White Mesa Mill Reclamation Plan

Revision 3.2 - Final

Addendum/Changed Pages

White Mesa Mill and Tailings Management System

FIGURE A-5.1-1
RECLAMATION COVER GRADING PLAN
RECLAMATION PLAN REV. 3.2 - final

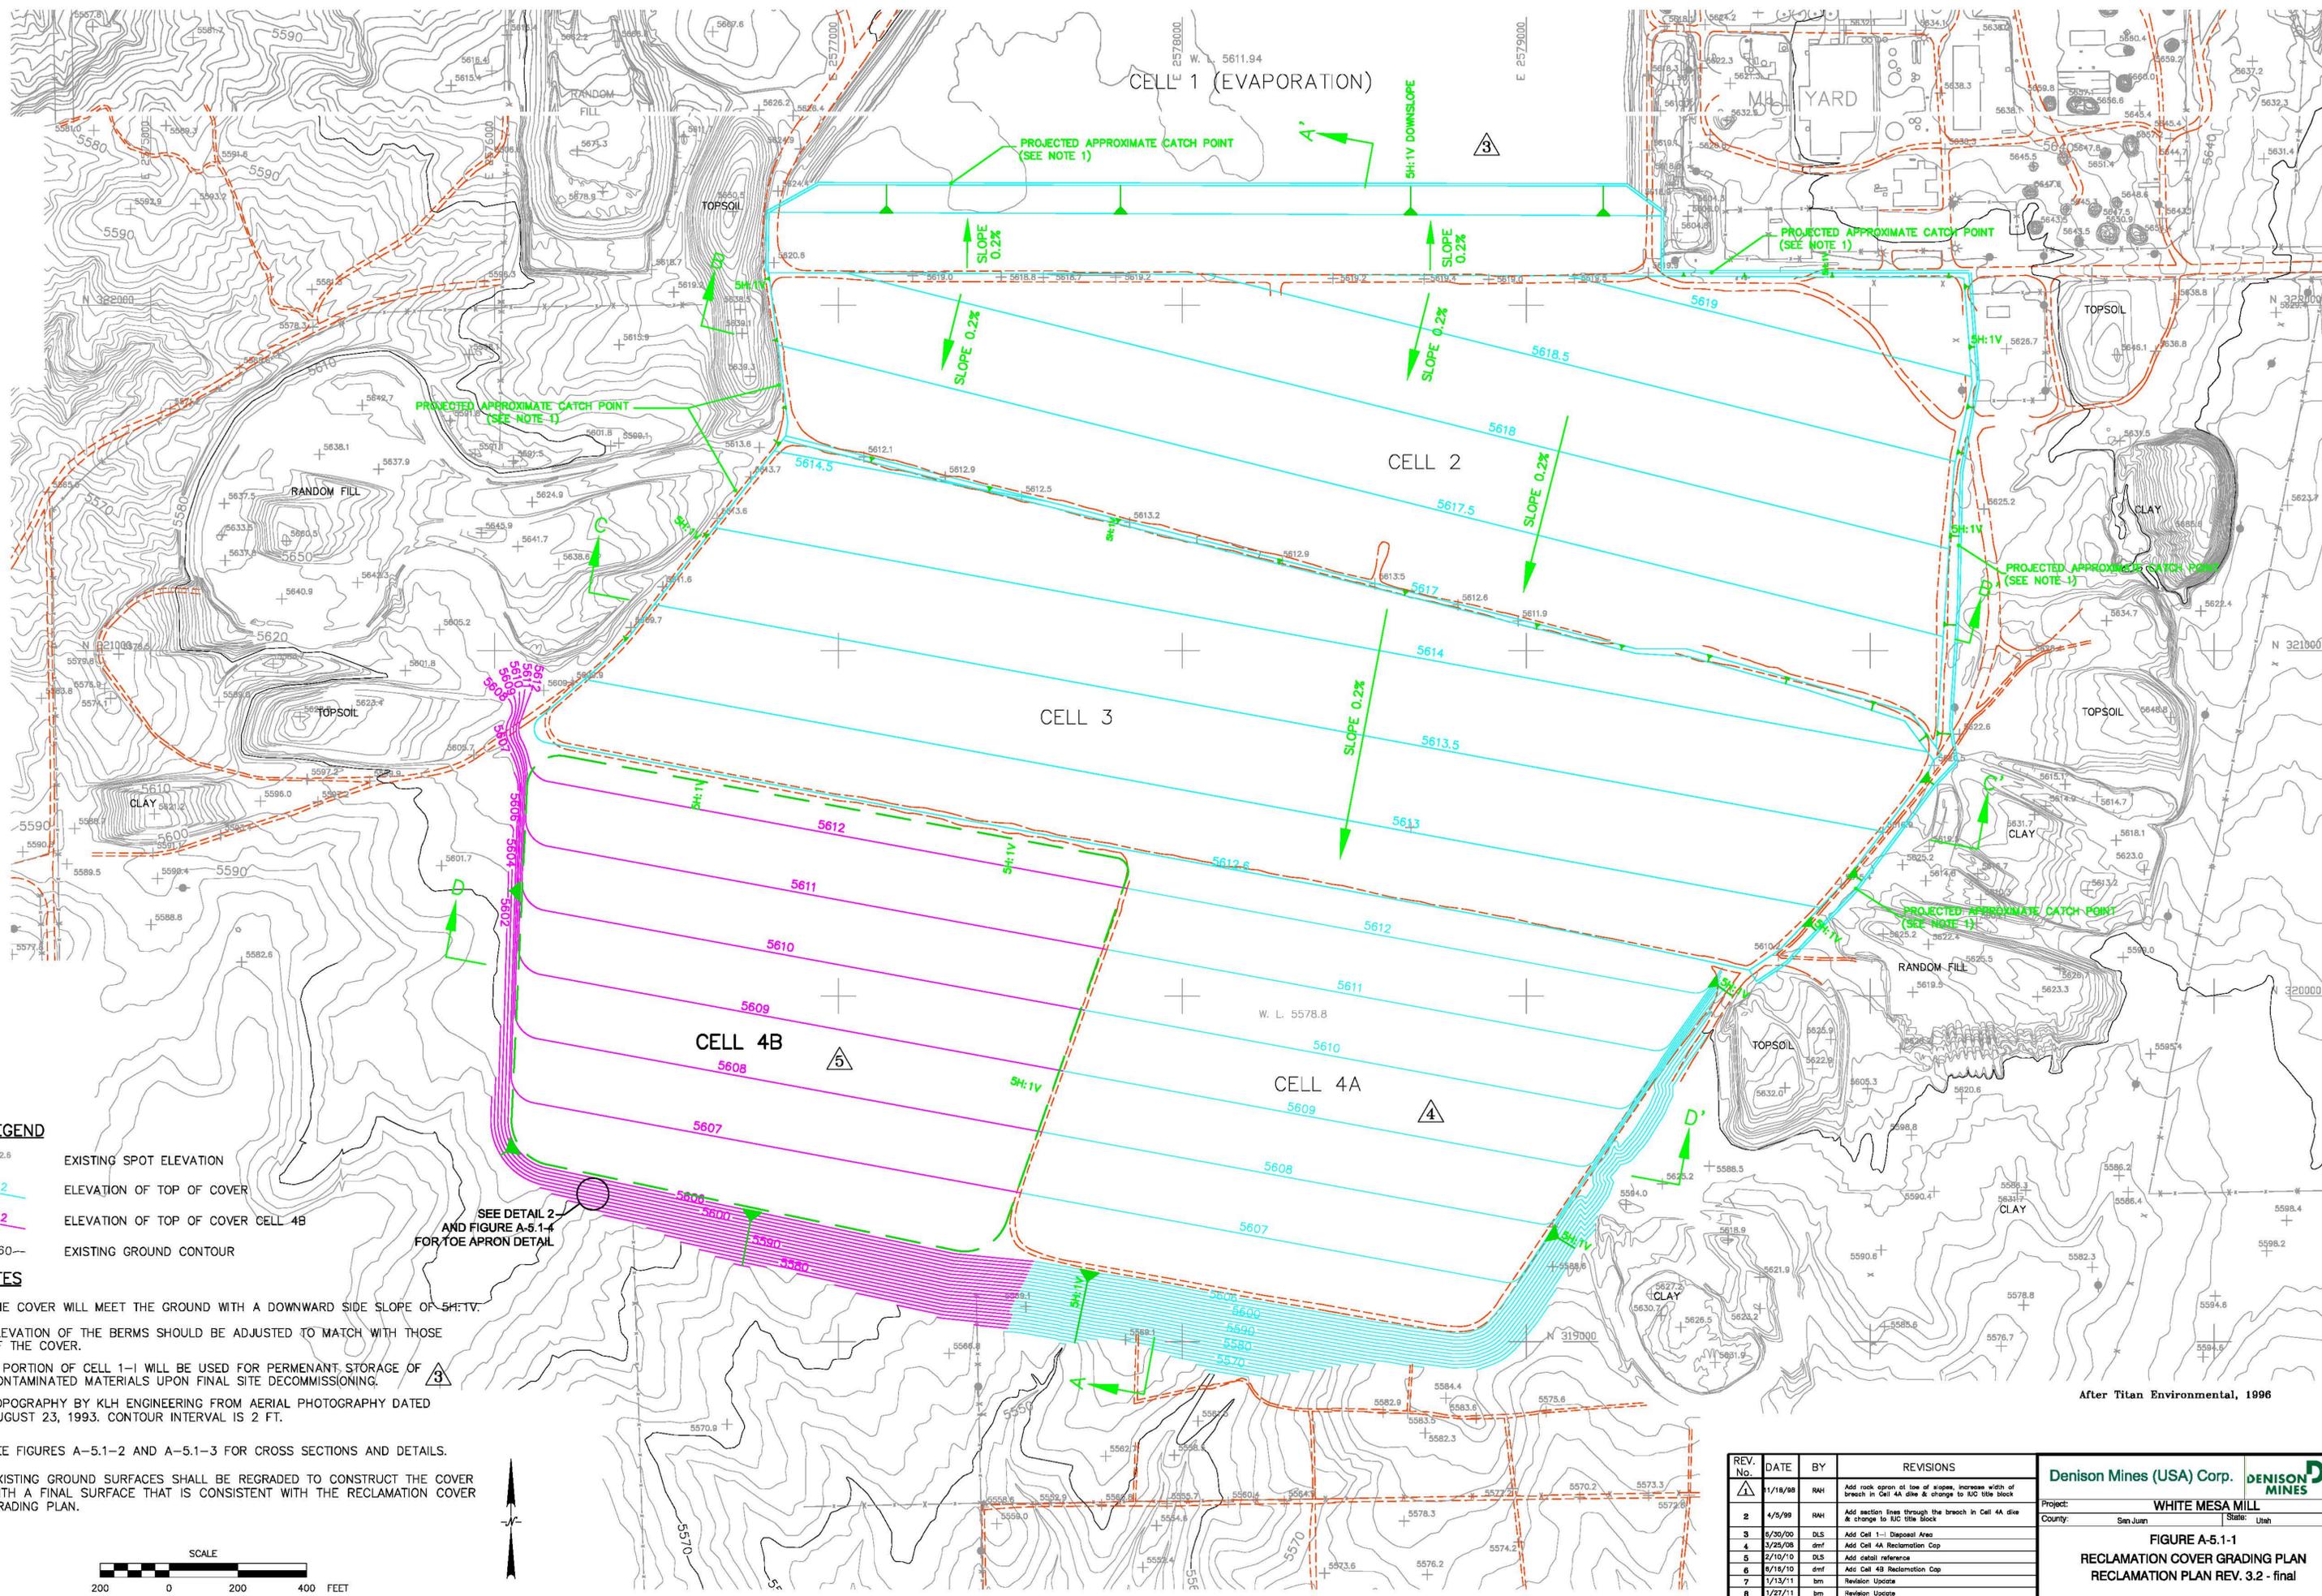
- Completely replaces the content of Rev. 3.1, by replacing Figures A-5.1-1, A-5.1-2 and A-5.1-3 of Rev. 3.1, which was the entire content of Rev. 3.1.
- For Rev. 3.0, replaces with revised documents the text, figures, tables, appendices, and attachments included under this cover that correspond to the same items in existing Revision 3.0.
- Adds the new documents under this cover to the Reclamation Plan.
- Maintains the remaining balance of the contents of Approved Revision 3.0,
